#### 195th session

## **Proposal for Supplement 21 to the 06 series of amendments to UN Regulation No. 48 (Installation of Lighting and Light- Signalling Devices)**

### **Submitted by the Working Party on Lighting and Light-Signalling\***

## “Annex 16

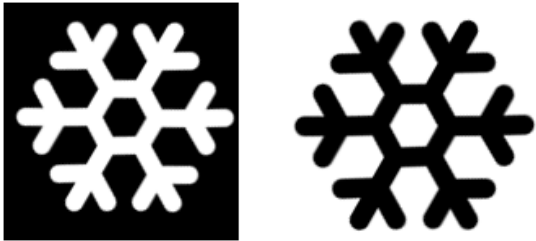
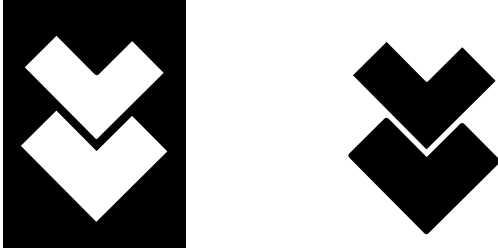
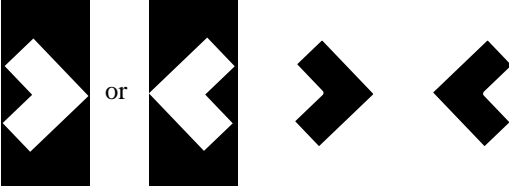
Annex 16, amend to read:

### Symbols and patterns for the use as Driver Assistance Projections and Explanations of the Warnings/Highlights

<i>Symbols and Pattern</i>	<i>Use case</i>	<i>Conditions and remarks</i>
	Slippery road warning	
	Risk of collision warning	<p>Triggered when the relative speed is larger than 30 km/h and Risk of Collision Time is less than 1.4 s.</p> <p>Flashing at 4.0 hz +/- 1.0 hz allowed.</p>

Wrong way warning	Activated when the vehicle is entering a one-way road or a highway in opposite direction.  Flashing at 4.0 hz +/- 1.0 hz allowed.
	Lane keeping assist warning	Activated if the vehicle unintentionally exits its lane.
 <p>This figure is showing an example of the basic quadrilateral shape of the Driver Assistance Projection for predicted trajectory, as seen from the driver's perspective of a car in straight forward motion. The dashed lines are not part of the projection. They are a representation of the lines delineating the lane on which the vehicle is travelling, and only added to clarify the image and lateral boundaries of the predicted trajectory projection.</p>	Predicted trajectory	This shape may change when adapted in conformity with the requirements in paragraph 5.35.12.
